Southern California Edison
Circle City and Mira Loma-Jefferson PTC A.15-12-007

DATA REQUEST SET A1512007 ED-SCE-02

FIGURE 1-1: ELECTRICAL NEEDS AREA

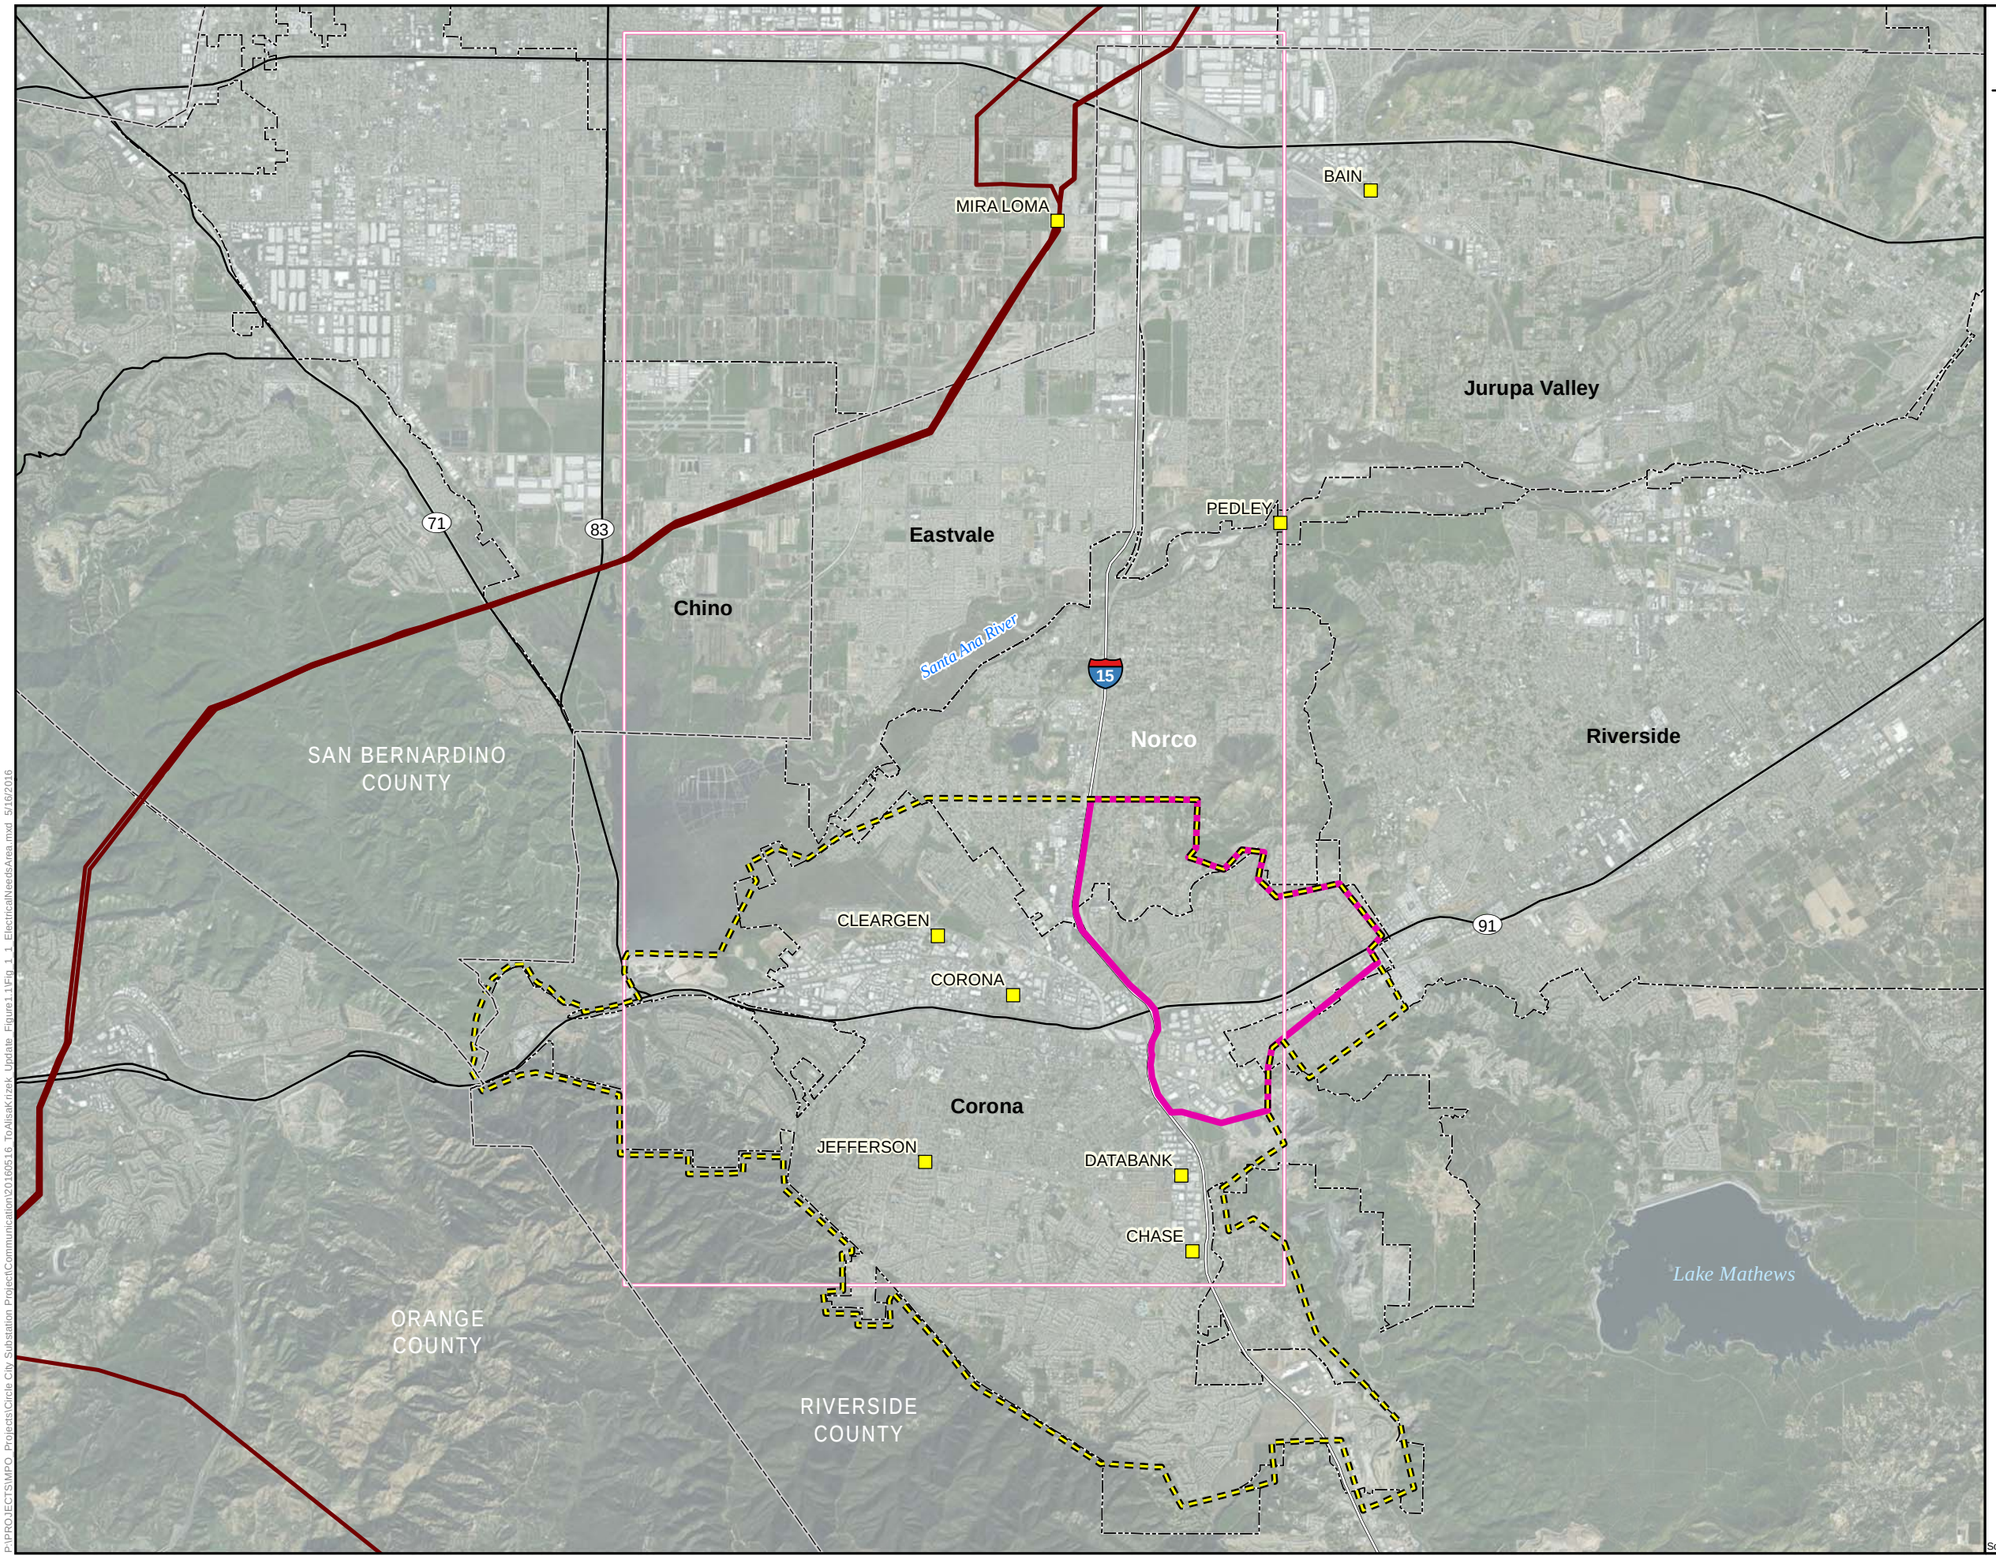
Regarding PEA Figure 1-1, Electrical Needs Area, please identify and provide supporting GIS for the location of the Bain Substation, as we understand that telecommunications upgrades are proposed there.

Attached is a revised Figure 1-1 and associated GIS data identifying the location of Bain Substation.

MIRA LOMA SYSTEM
66 kV Lines
(existing)

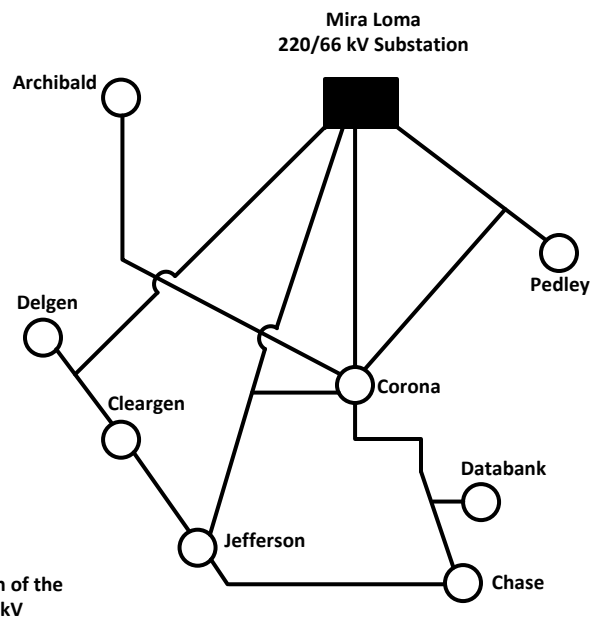
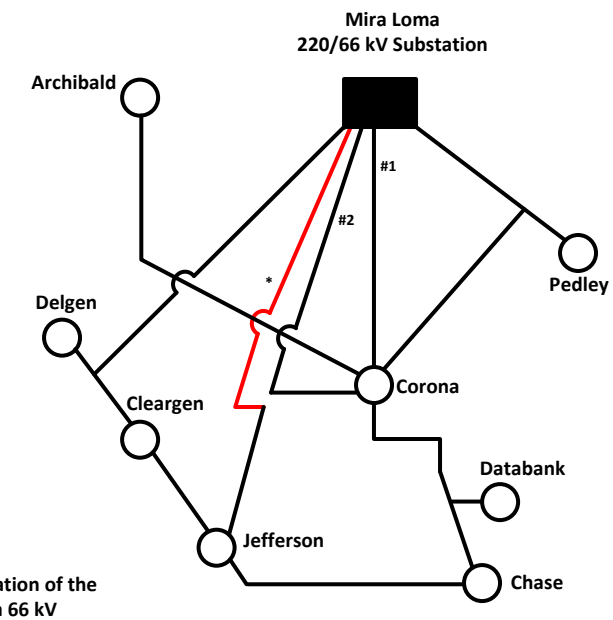
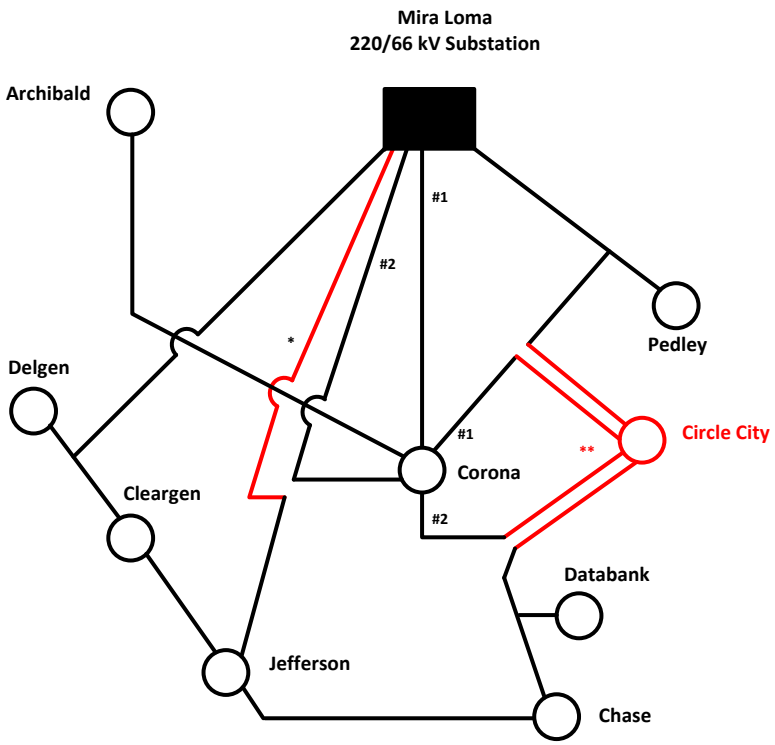
Please revise PEA Figure 1-2 to include the existing and proposed configurations for the Mira Loma-Jefferson Subtransmission Line, or provide an additional figure to illustrate that information.

Please see the attachment titled "A1512007_ED-SCE-02_Q3.pdf" for a figure that illustrates the existing and proposed configurations of the Mira Loma 66 kV System.

DROP IN MEER
B-WALL INTERIOR AND EXTERIOR ELEVATION

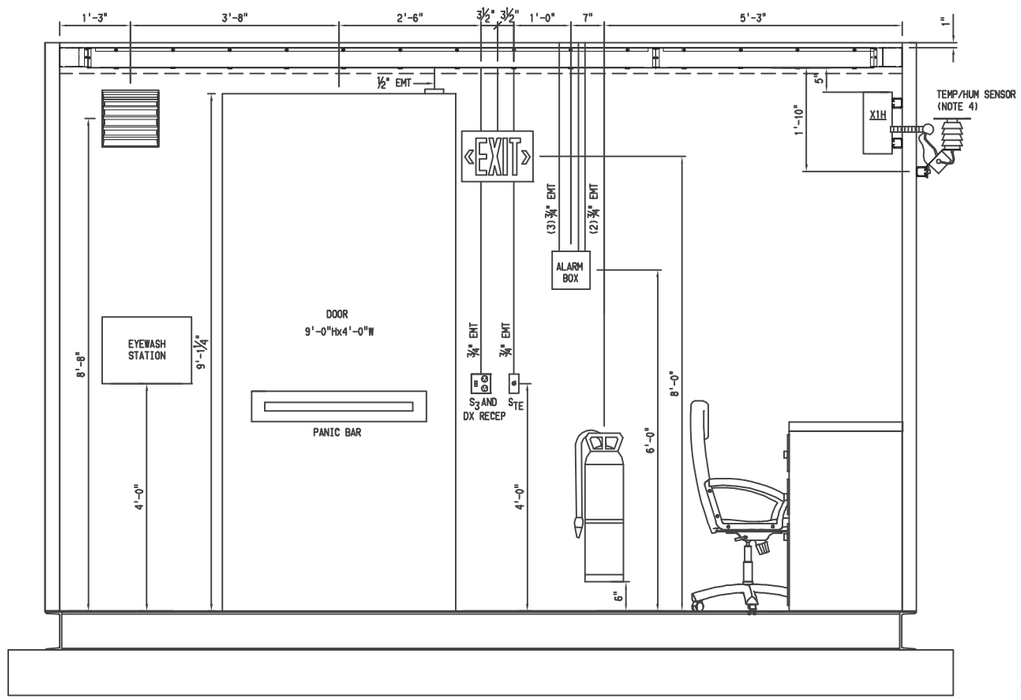
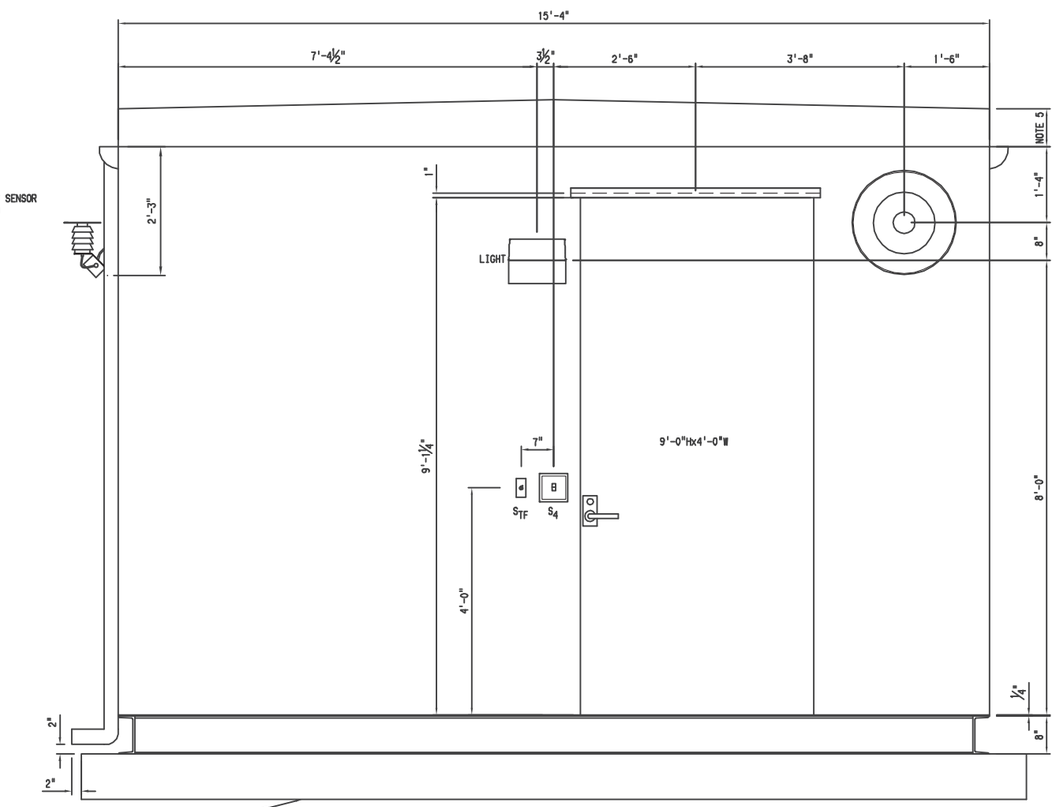
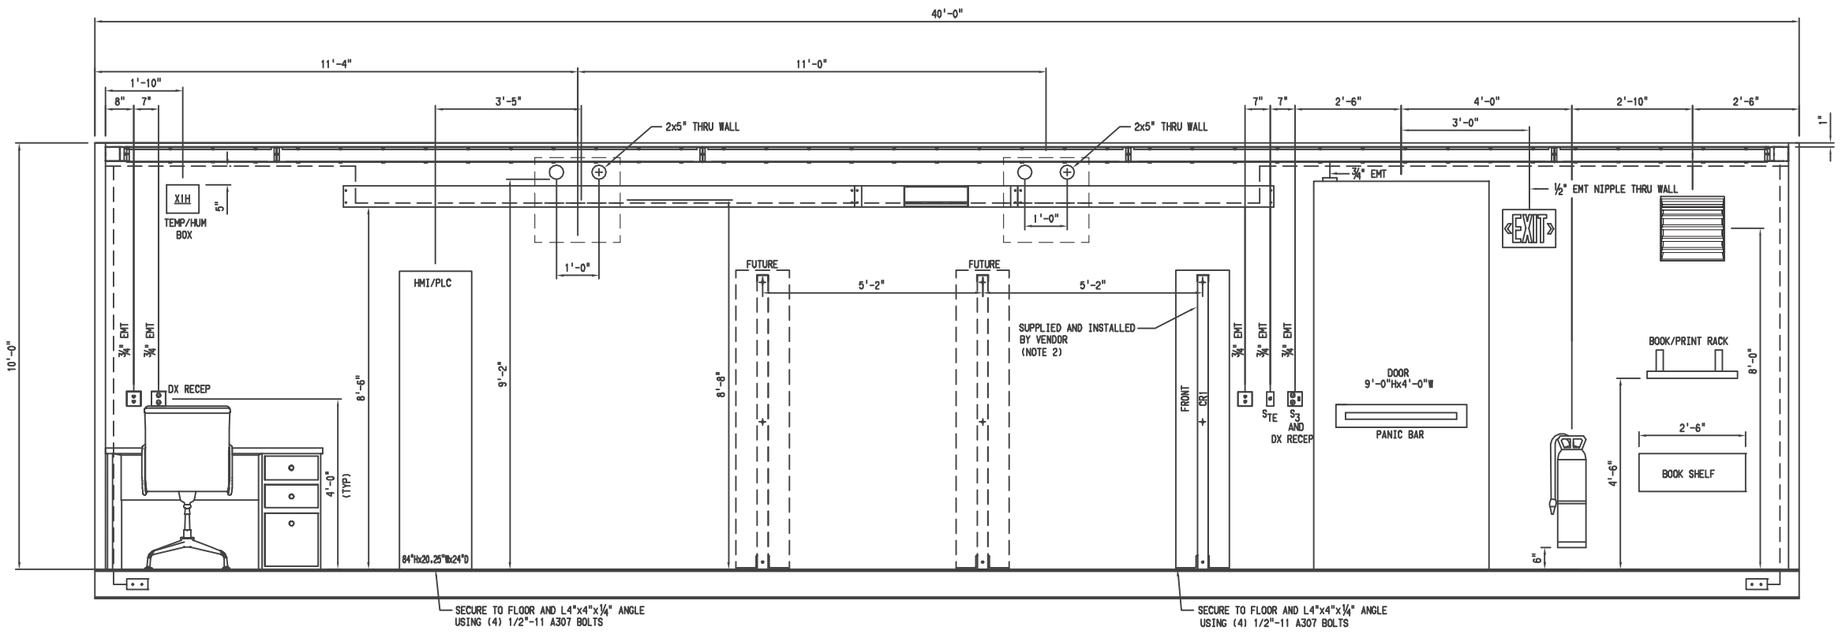
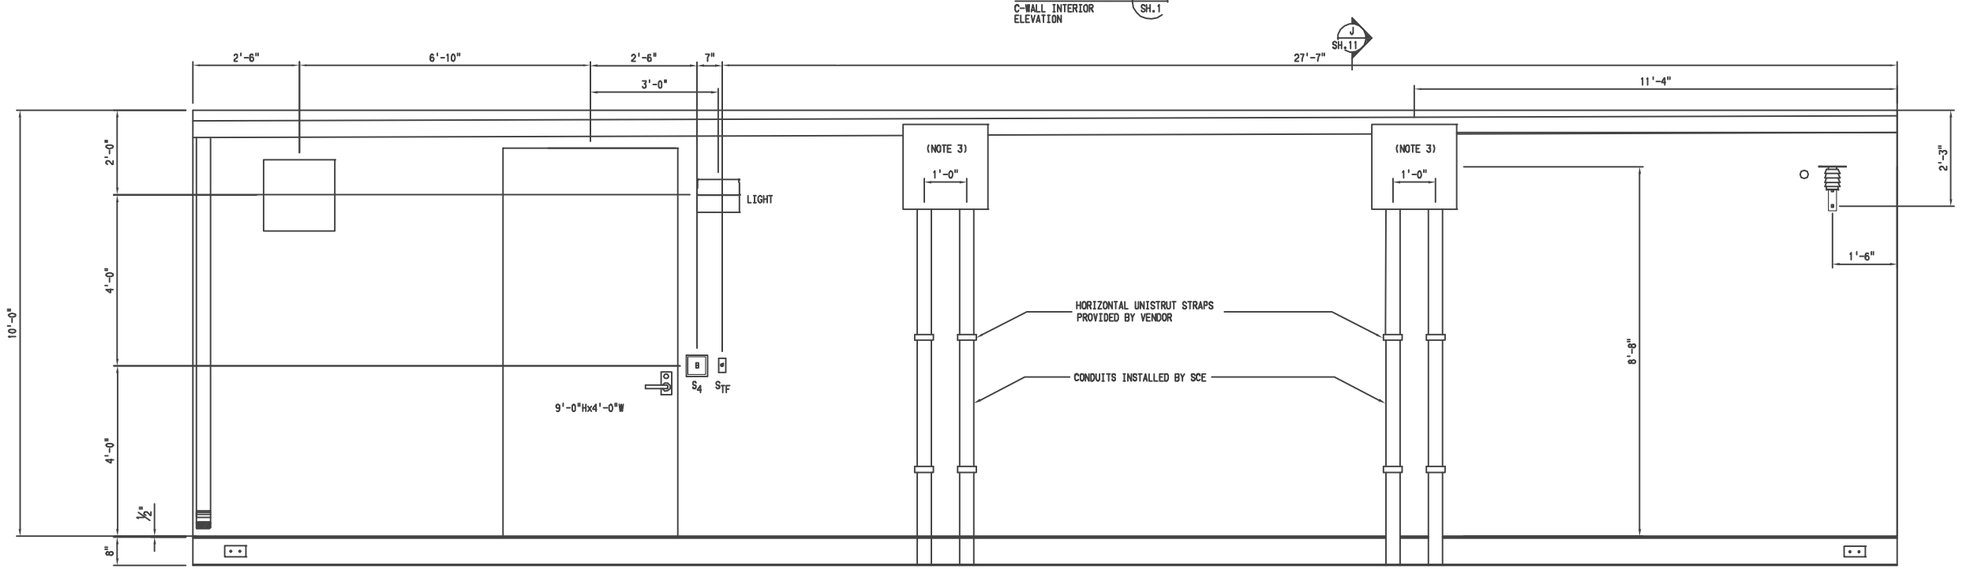
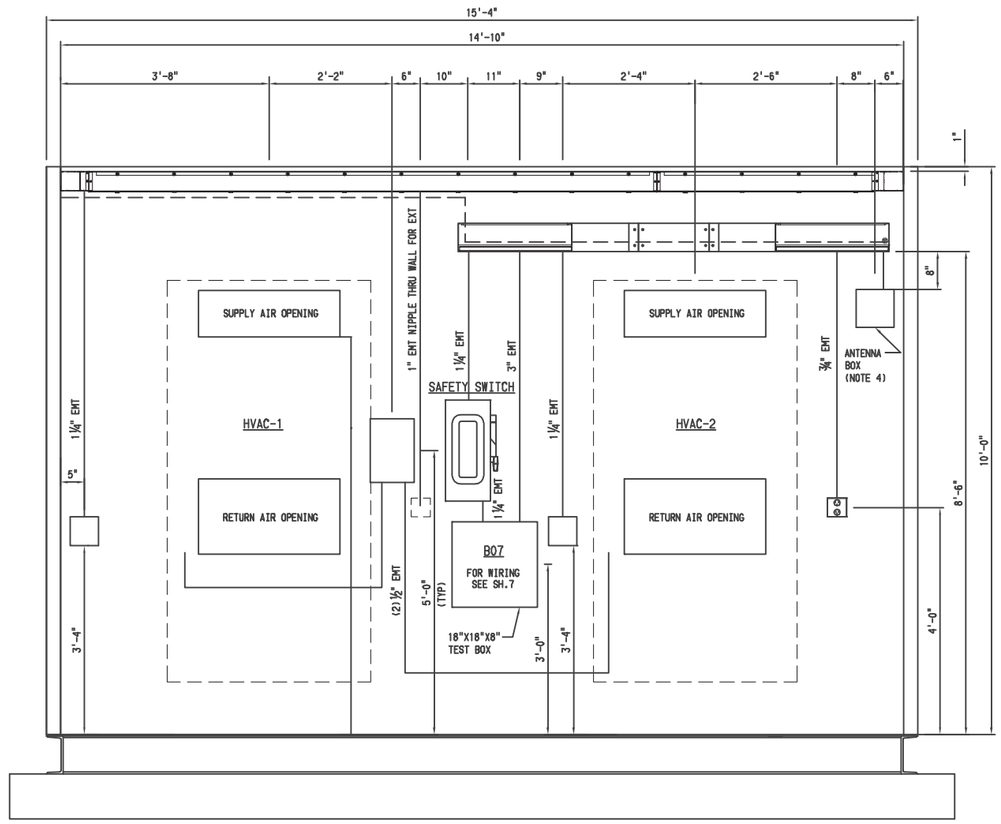
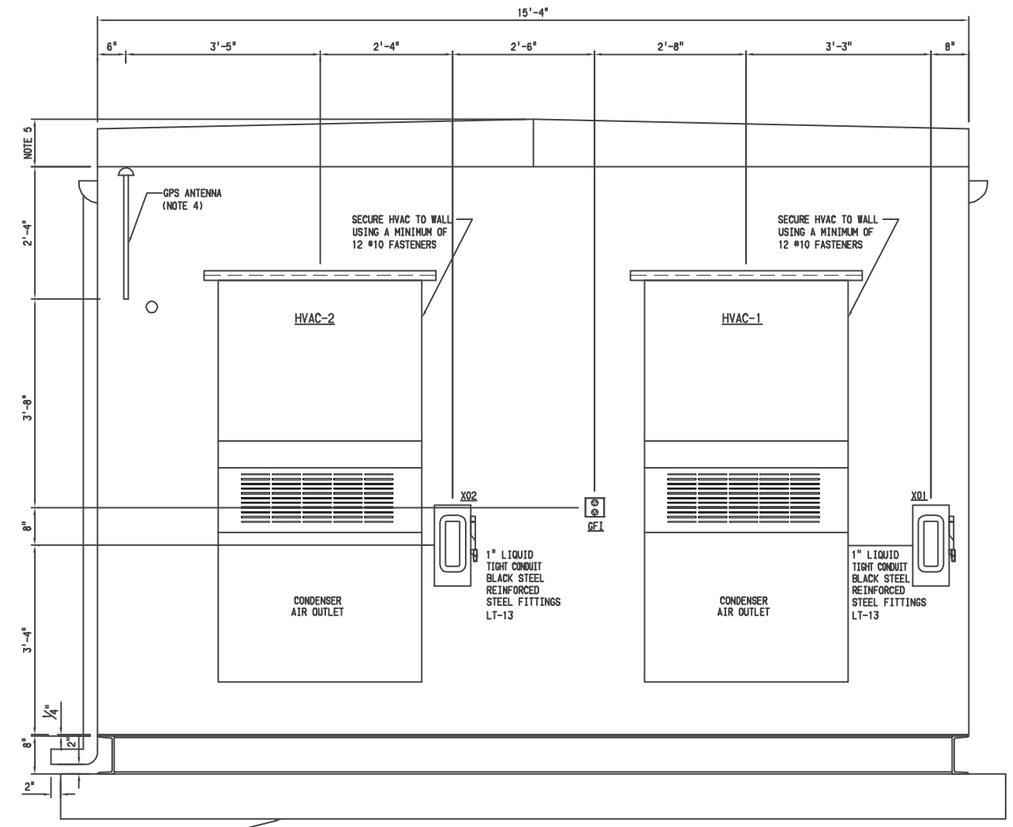
a. Please provide a cross-section or an explanation indicating whether the roofline is proposed to be peaked or flat.

The MEER will have a flat roofline. Please see the attached MEER cross-section file.
